Windsor Bridge Replacement Project

Traffic Review of Information Provided by the Applicant (Roads and Maritime Services)

FINAL REPORT

Prepared for NSW Department of Planning and Infrastructure

Figure 2.1.2b: Option 7 – Heavy Movements at Macquarie Street and Court Street Intersections

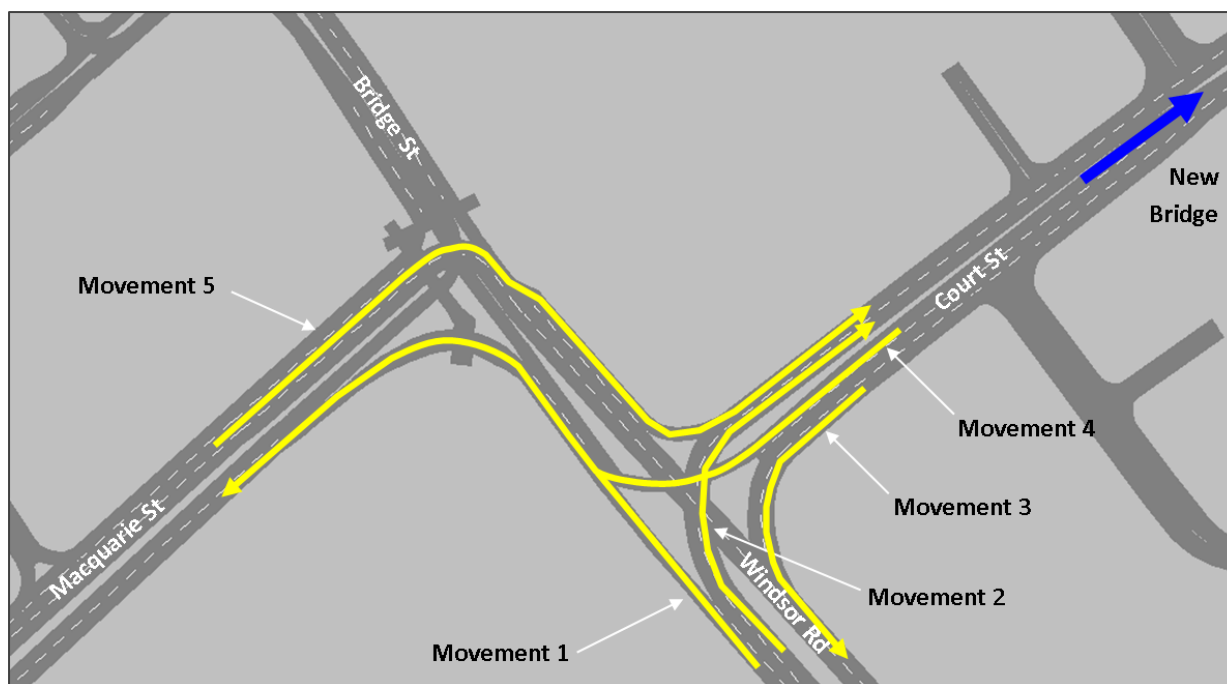
Based upon the traffic modelling of Option 7 provided by RMS (i.e. 2009 AM and PM VISSIM micro-simulation modelling), it appears as though the heaviest movements at these intersections are expected to be (see **Figure 2.1.2b** below):

We have considered the likelihood of queuing as a result of these heavy movements, and our comments are as follows:

Movement 1: The left turn into Macquarie Street is a continuous movement (opposed only by a zebra crossing), and therefore we expect that queuing back is unlikely to be an issue for this movement

Figure 2.4: Preferred Option in EIS

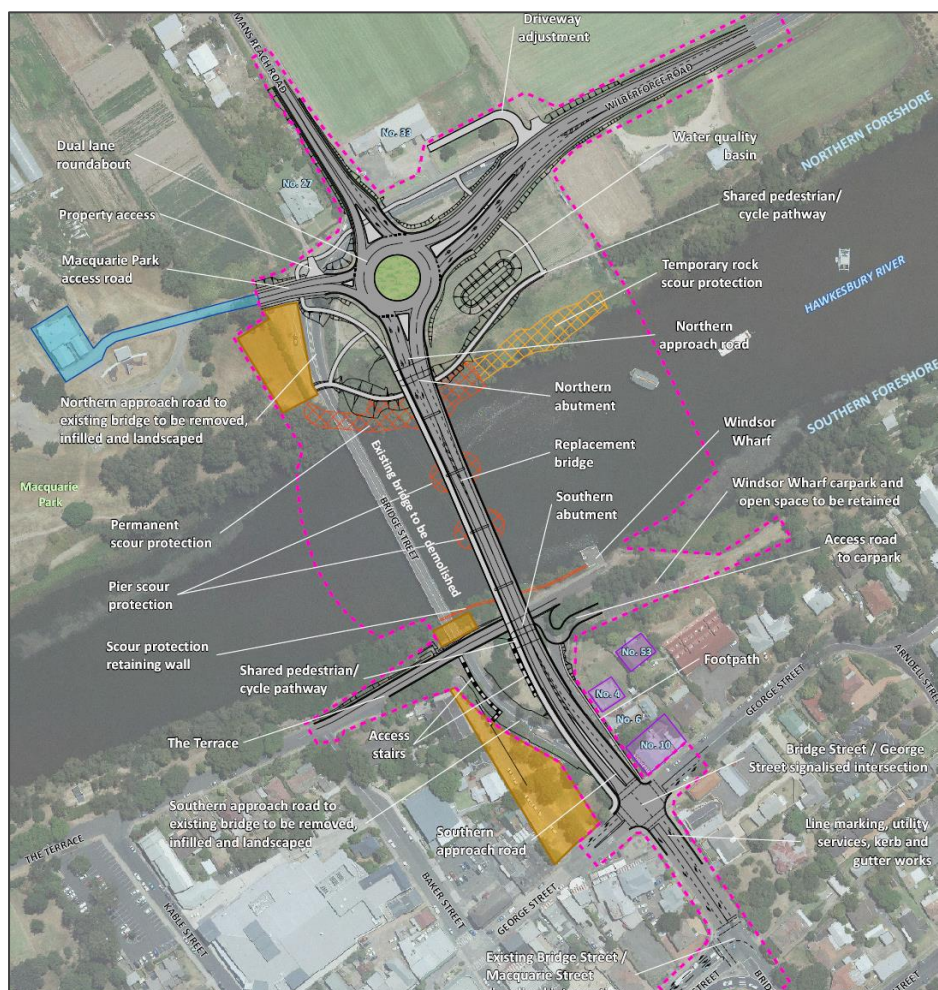
We have reviewed the relevant sections of the Project Environmental Impact Statement (EIS), which include the Traffic and Transport Chapter (Chapter 7.3), and the Traffic and Transport Working Paper (Working Paper 4). These documents are largely a compilation of the information contained within the previous traffic reports (i.e. the Options Report and the Traffic Modelling and Evaluation of Options - Preliminary Report), with the exception of two key modifications (see **Figure 2.4** below):

- the proposal to upgrade the Wilberforce Road / Freemans Reach Road intersection to a dual circulating lane roundabout, rather than a signalised intersection as proposed in previous documents; and
- the proposal to signalise the Bridge Street / George Street intersection at the same time as the construction of the new bridge (rather than at a later date as part of 'Stage 2' of the project).

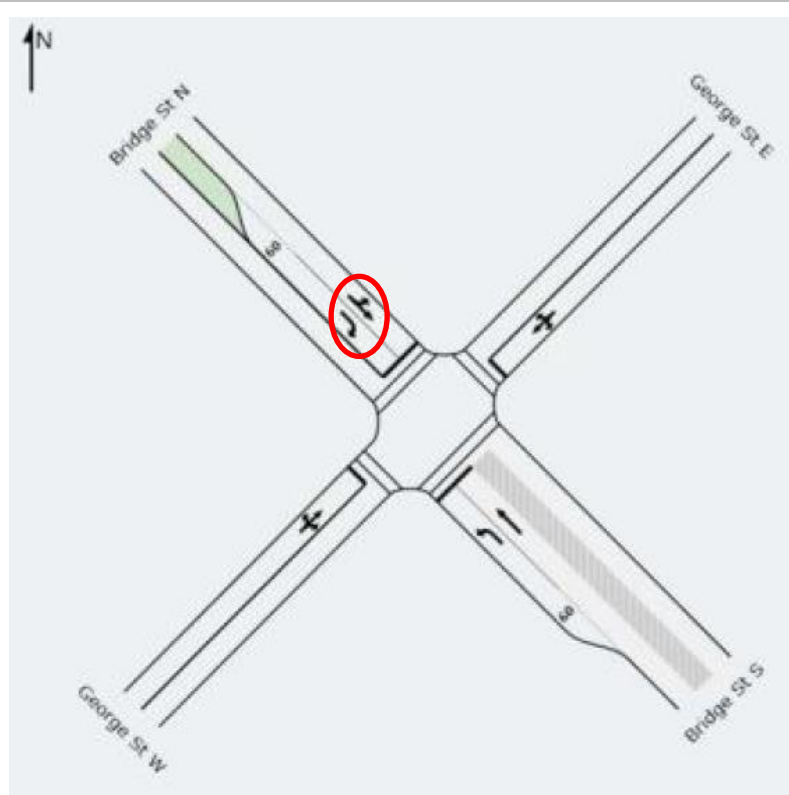
We note however that the modelling of the Bridge Street / George Street intersection and the Bridge Street / Macquarie Street intersection undertaken by RMS indicates that:

- The Bridge Street / George Street intersection is expected to be operating very close to acceptable limits of operation at the assumed year of opening of the project (2016), with limited spare capacity; and

- The Bridge Street / Macquarie Street intersection is expected to be operating outside of acceptable limits of operation at the assumed year of opening of the project (2016).

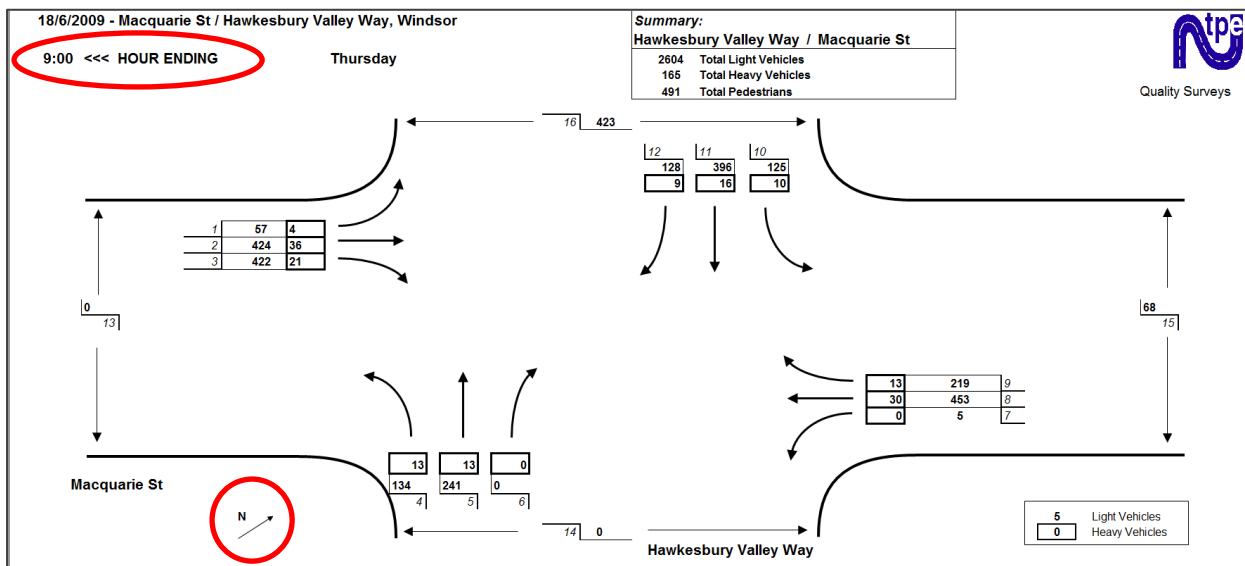
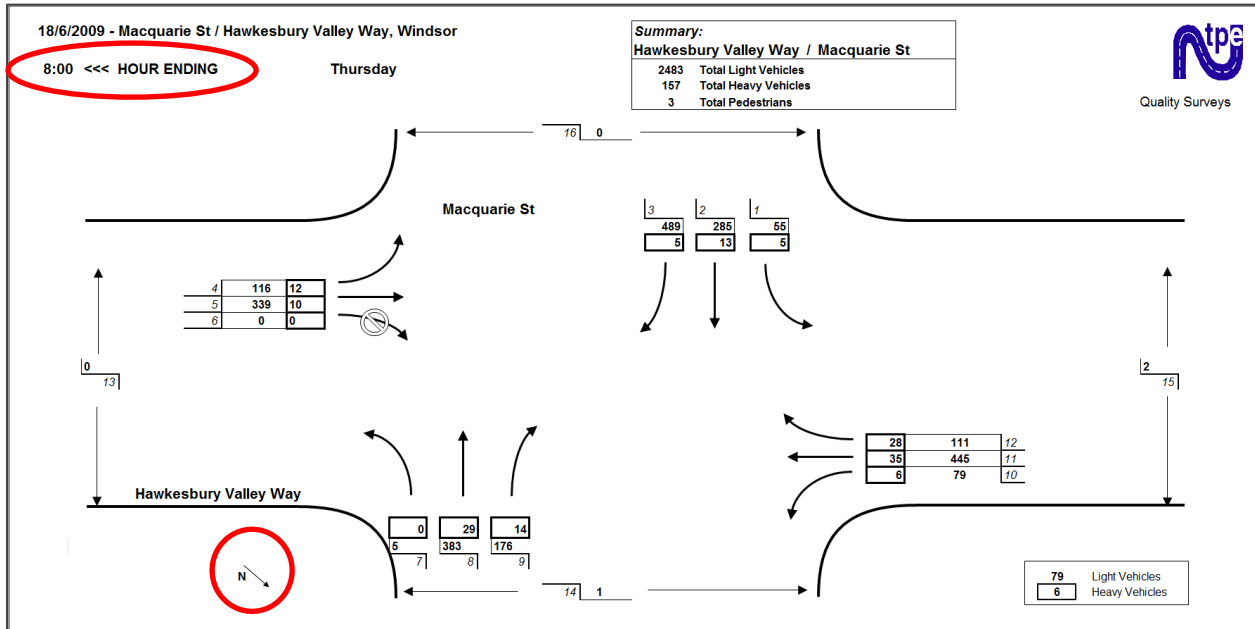
Whilst these two figures appear to provide the results of traffic counts undertaken at the same intersection on the same day, we note that the total intersection volumes presented in each of these figures is quite different (i.e. 2769vph in Count 1, and 3040vph in Count 2, for the time period from 8:00am – 9:00am). Note the orientation of the intersection in each of these figures is different.

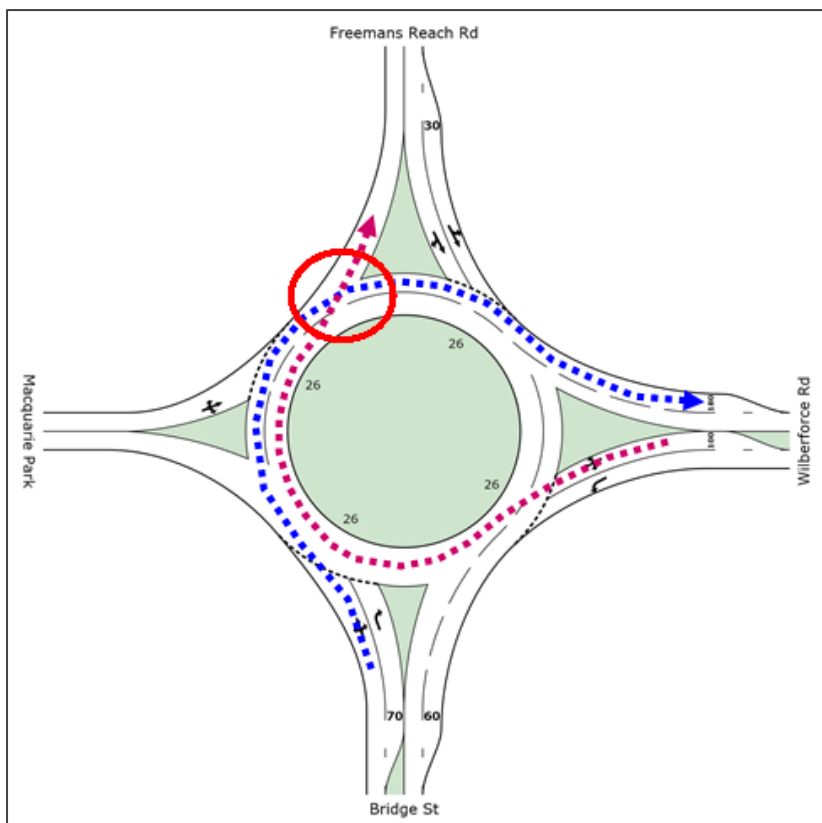
We expect that the movements may be different in the concept design, due to conflicting movements on the roundabout if the lane designation was to be as assumed in the SIDRA modelling (see figure below).

It would appear as though the SIDRA modelling may not have been updated to reflect the amended lane designations as shown in the Concept Design. This however is just our assumption and should be confirmed with RMS.

Conflicting Movements – EIS SIDRA Model Configuration

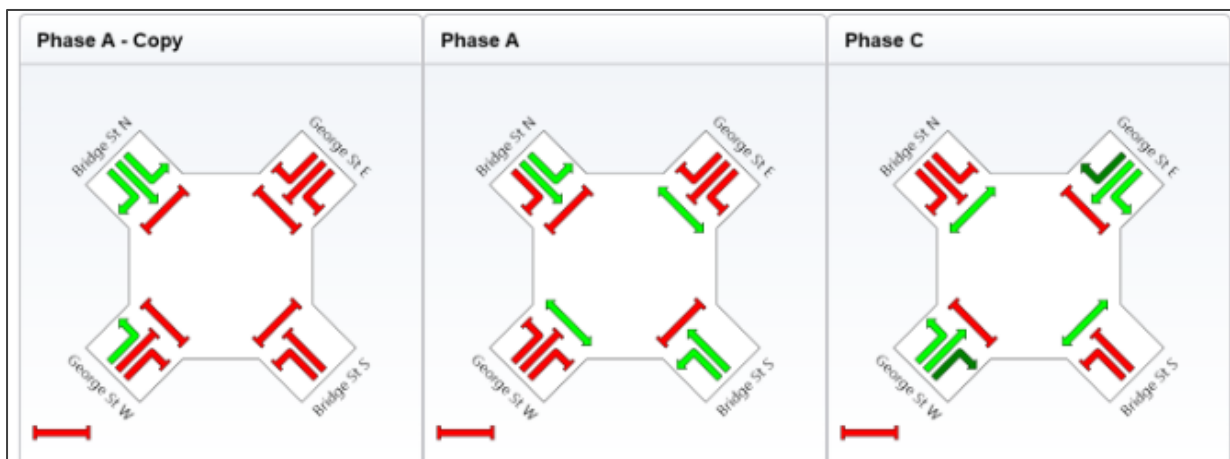
Note: While this arrangement is legally acceptable and does occur at some roundabouts, it is preferable to avoid this arrangement where possible.

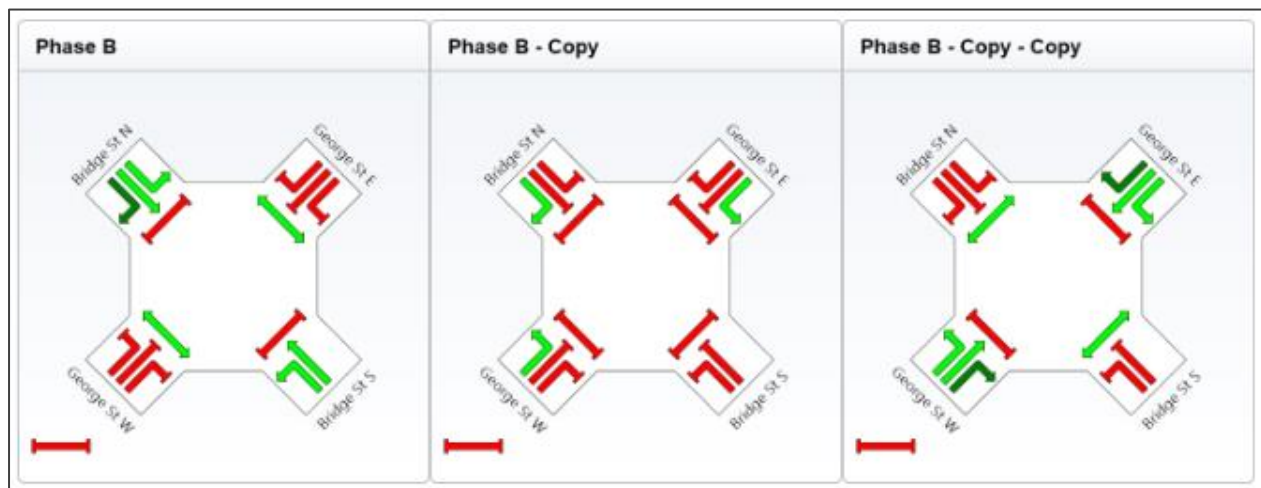
Several options have been modelled for this intersection, but most involve phasing arrangements which include:

We would recommend that alternative phasing arrangements, which do not include filter right turn movements from shared lanes or right turn movements filtering through pedestrian movements, be pursued if possible.

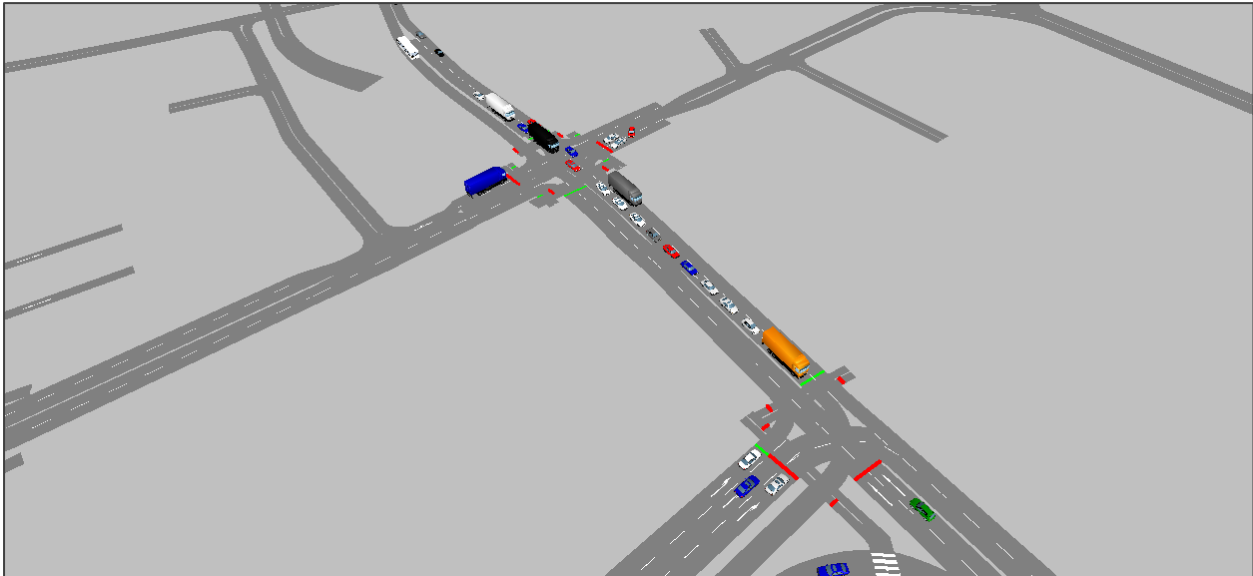
- As indicated in the figures overleaf, the (future) additional southbound lane on the bridge would appear to offer little benefit other than to accommodate traffic queuing back from the George Street and/or the Macquarie Street intersections.

- It appears as though the following vehicle speeds on the bridge have been applied:
 - 60km/hr northbound; and
 - 80km/hr southbound.

These speeds should be adjusted to reflect the speed assumed in the design of the preferred option (50km/hr).

Figure 2.6.12a: Roundabout Components

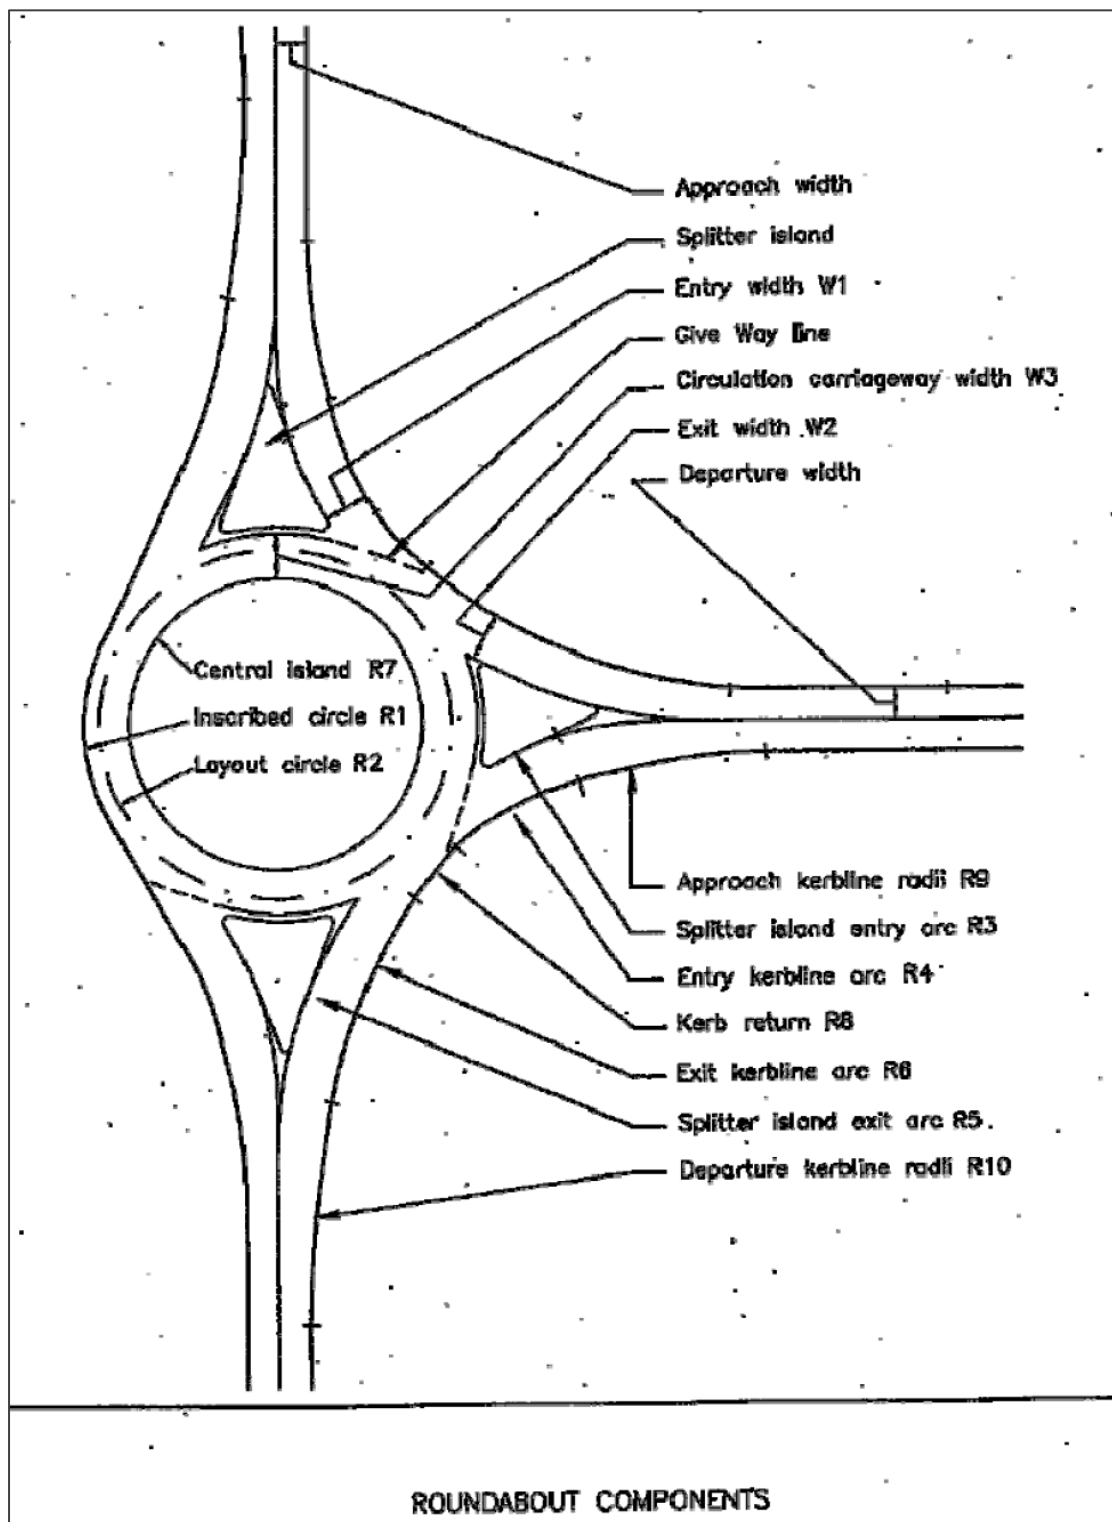
We have undertaken a high level review of the configuration of this roundabout against the relevant design requirements (see **Figure 2.6.12** overleaf). A summary of the results of this assessment is provided in **Table 2.6.12** below.

In summary, the roundabout design appears to be generally in accordance with RTA requirements (subject to checking deflection), with the exception of the splitter island entry arc (R_3) on the southern approach. This should not exceed 100m, to limit the speed of vehicles entering the roundabout.
